YE SERVICE NEWS

Subject	Change of Material of Pro	No. :YEN-CP-23020-3 Date:2020/05/19	
Engine	6EY18(A)L(W), 6EY22(A)(L)W	Use	All uses
Model		Engine Nos.	All engines

Table: Detail for Change of Protection Ring

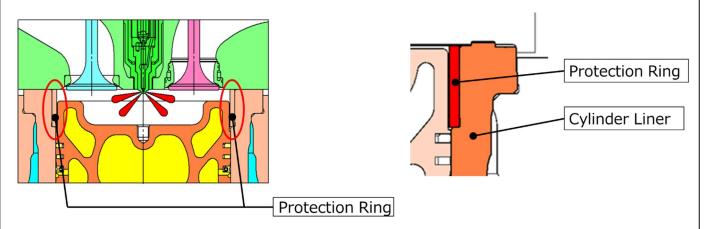
The material of protection ring for 6EY18 and 6EY22 engine model has been changed for improving durability and fitness with cylinder liner as below table . This change will not affect to engine performance.

6EY18		6EY22	
	Current Type	New Type	Current Type	New Type
Parts Number	146623-01121	146623-01230	150633-01121	150633-01110
Material	SUS304	FC250	SUS304	FC250
Assy. Number of Cylinder Liner	746623-01901-C	146623-01240-C	150633-01140-C	150633-01241-C

If you have plan to replace protection ring at maintenance, replacing to new type is recommended...
